Job Name: Abbey Road, Phase 3

Note No: TN02

Subject: Response to Transport Comments

Appendix A – Parking Survey Plans

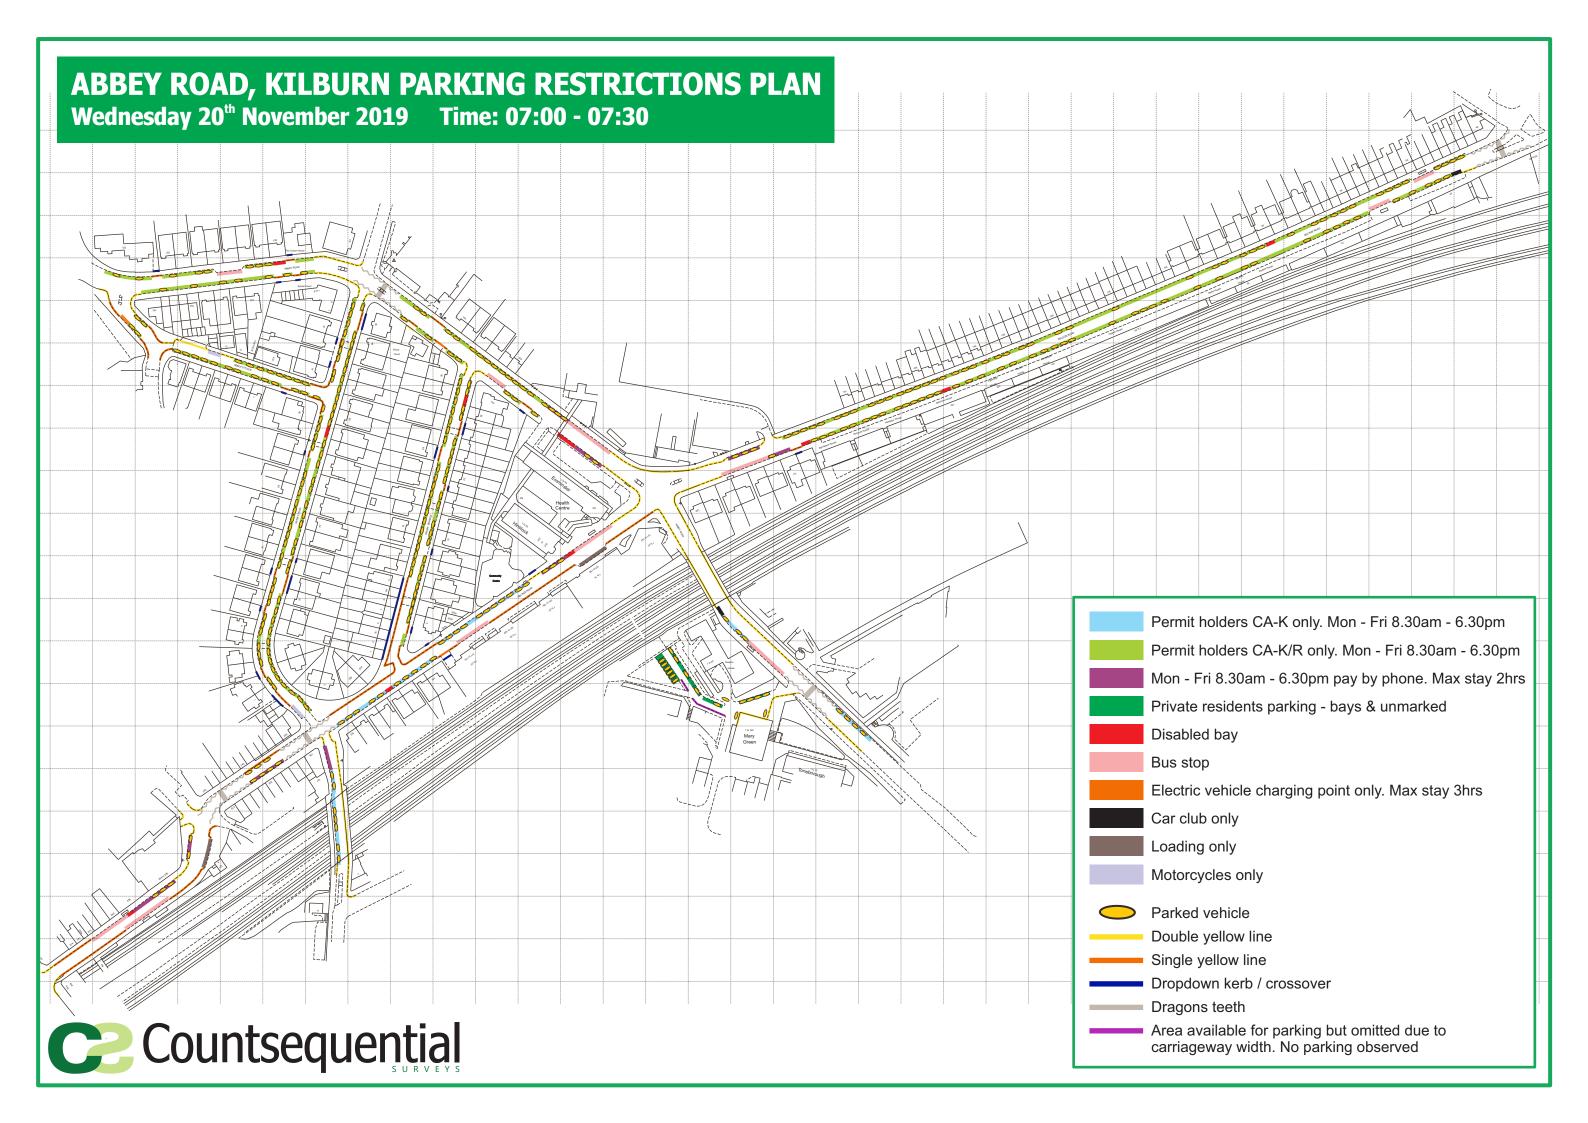
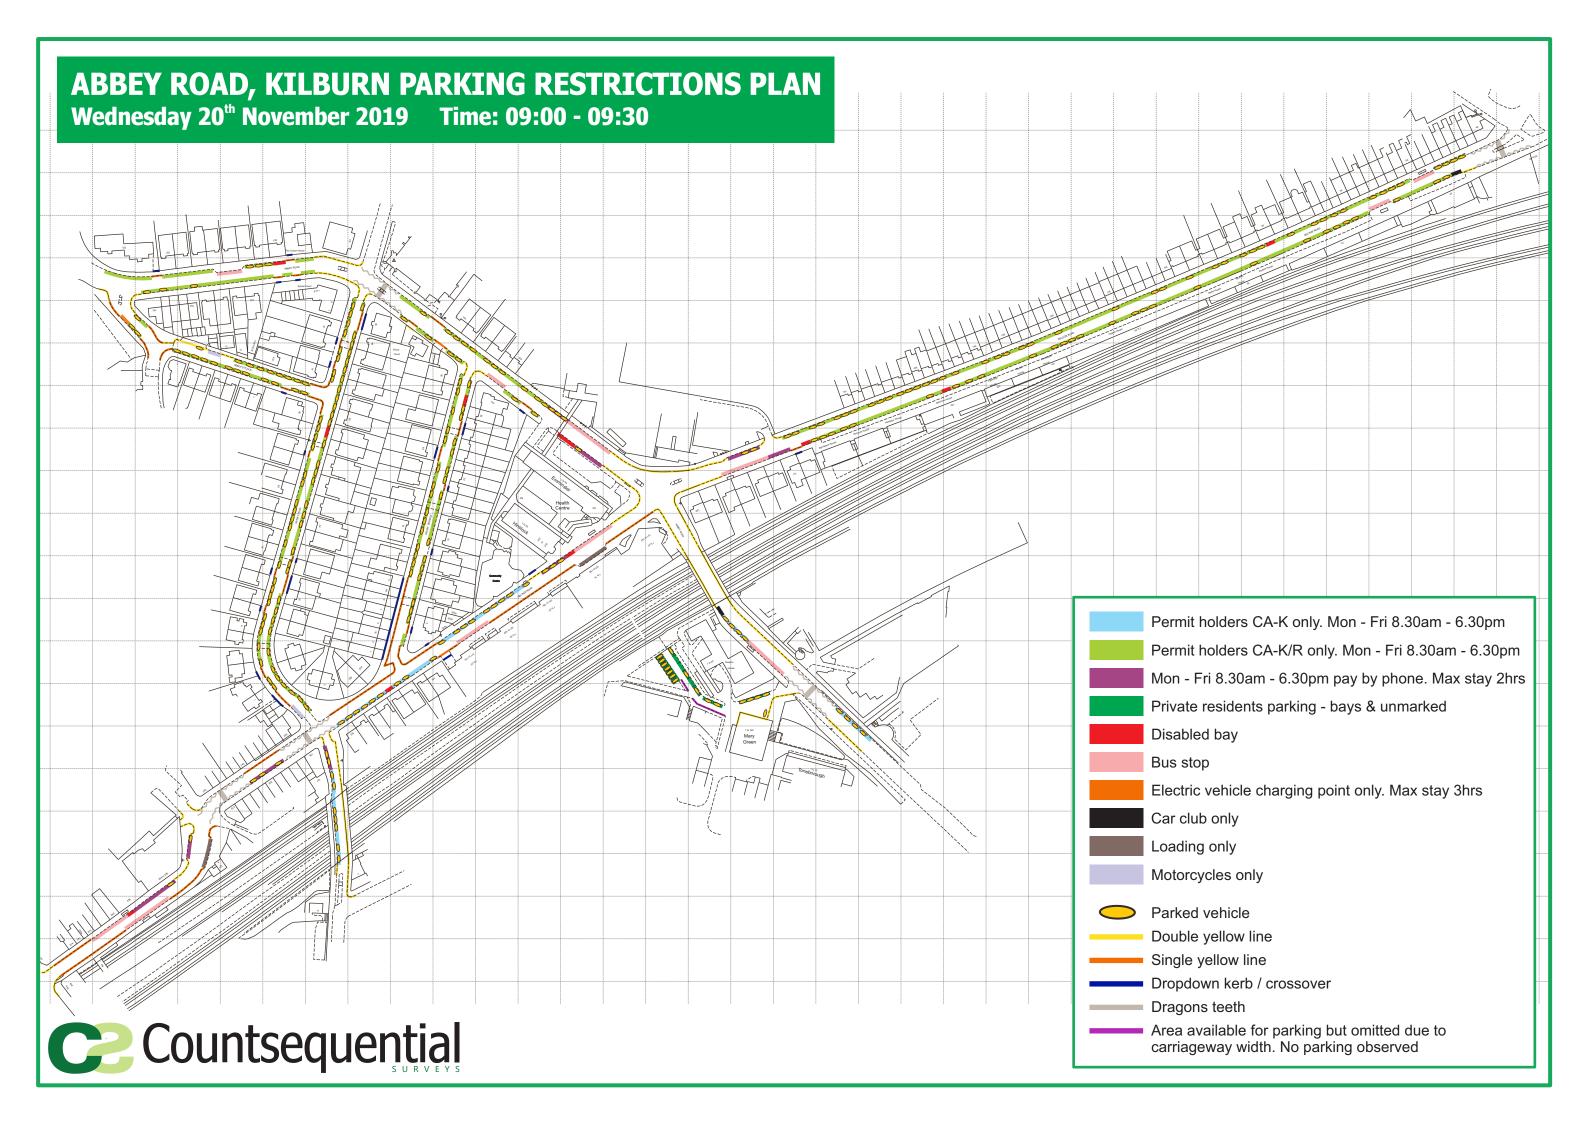
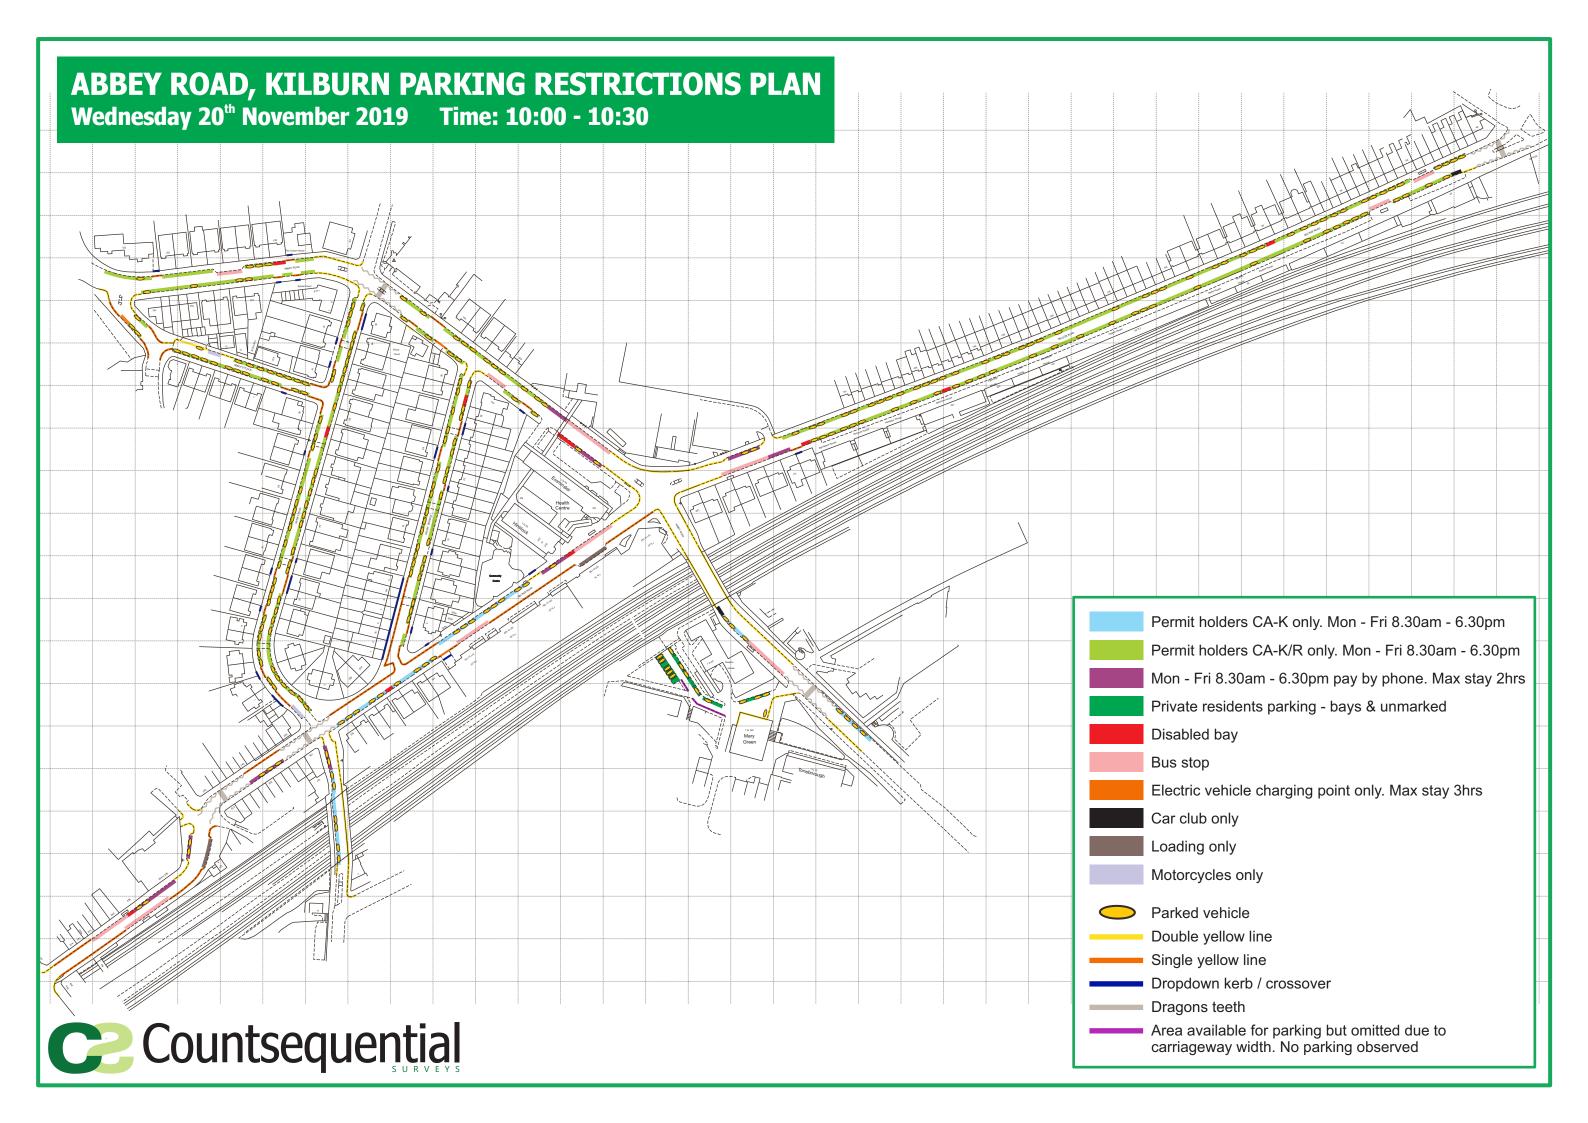
- 2. The TA refers to parking survey and presents a summary of the results. In order to verify how the figures were derived, we need plans etc. This is a standard requirement of the Lambeth Parking Survey Guidance viz: A map or plan showing the measurements used in calculating parking capacity should be supplied so that this can be verified by the Council. The parking survey may not be accepted if this is not supplied.
 - Please find the survey plans attached in Appendix A. These parking surveys were agreed and undertaken during discussions with Camden as part of Phase 2 of the scheme.
- 3. As mentioned in separate correspondence, I would seek clarification on the existing on-site parking whether any residents' parking privileges will be retained.

alternative location for the EV charging space	
Parking survey plans	The parking surveys were agreed and undertaken during discussions with Camden as part of Phase 2 of the scheme.	Appendix A
Resident's parking privileges	No parking privileges will be retained	
Cycle parking	252 long-stay cycle parking spaces have been provided as a Sheffield-2 Tier Stand as discussed.	Appendix B
Delivery and servicing	There is sufficient capacity to accommodate the expected delivery and servicing trips at any point during the day.

Appendix B – Broxrap Specification

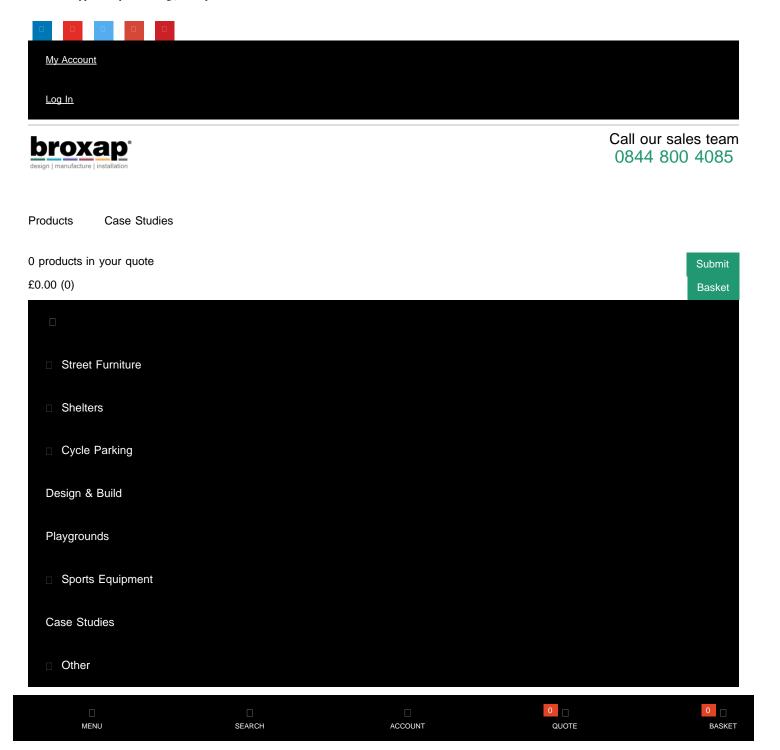
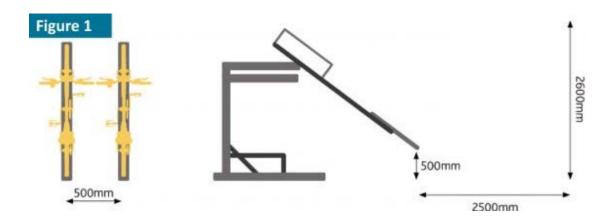
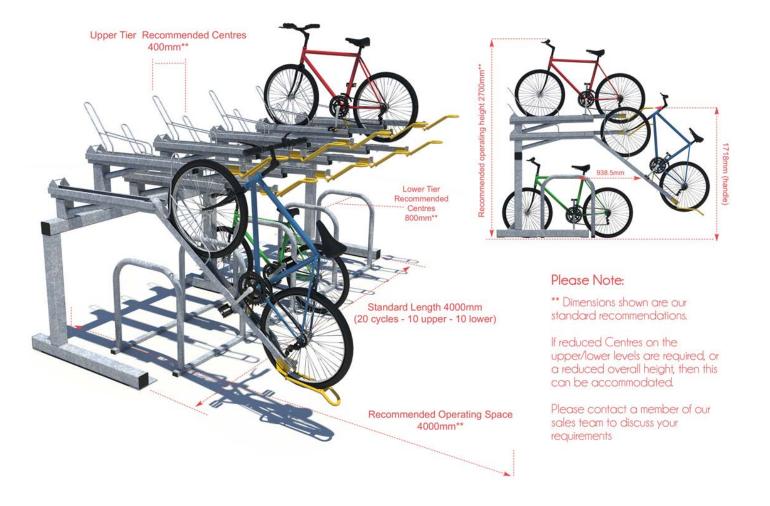
4. I am unable to equate the 252 Long-Stay cycle parking spaces, referred to in the TA, with the ground floor drawings submitted; there appears to be a shortfall of around 40%. Further explanation is required.

There are 252 long-stay cycle parking spaces provided. The ground floor planning drawing appears to have a shortfall because the type of product proposed to be used for the development are the Broxap Sheffield – 2 Tier System which provides a Sheffield stand (providing two cycle parking spaces) at the base for easy access with a top loading tiered cycle stand for second plan. The specification is attached in Appendix B. Each bay shown on the planning drawings are 1m wide by 1.8m long. Within each bay is one Sheffield stand (for two cycles at the base) and two top loading tiered cycle stands. Effectively accommodating four cycles per bay.
